# UNITED STATES PATENT AND TRADEMARK OFFICE

APPLICATION NO.	FILING DATE	FIRST NAMED INVENTOR	ATTORNEY DOCKET NO.	CONFIRMATION NO.
10/536,479	10/03/2005	Michael R Treat	COL221-227791(A)	6897

<b>Office Action Summary</b>	<b>Application No.</b> 10/536,479	<b>Applicant(s)</b> TREAT, MICHAEL R	
	<b>Examiner</b> Derek J. Rosenau	<b>Art Unit</b> 2834

## **DETAILED ACTION**

Figure A

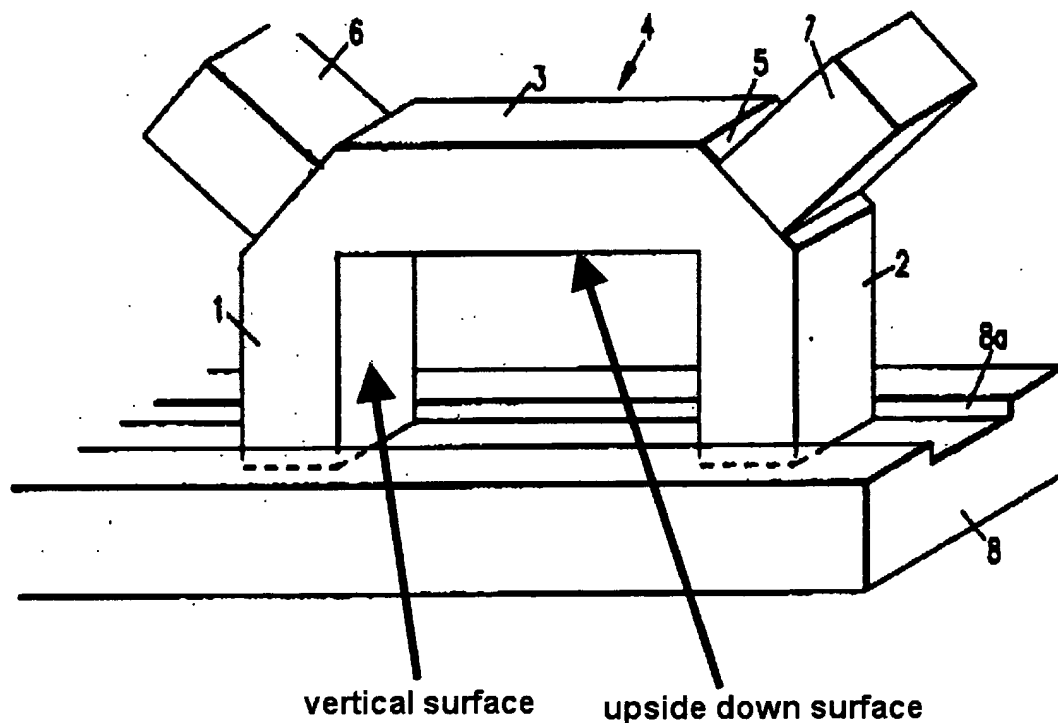
15. With respect to claim 6, Onishi et al. discloses the device of claim 5, wherein the surface (see Figure A below) is vertical.

16. With respect to claim 7, Onishi et al. discloses the device of claim 5, wherein the surface (see Figure A below) is upside down.

22. With respect to claim 13, Onishi et al. discloses the device of claim 12, wherein the surface (see Figure A above) is vertical.

23. With respect to claim 14, Onishi et al. discloses the device of claim 12, wherein the surface (see Figure A above) is upside down.
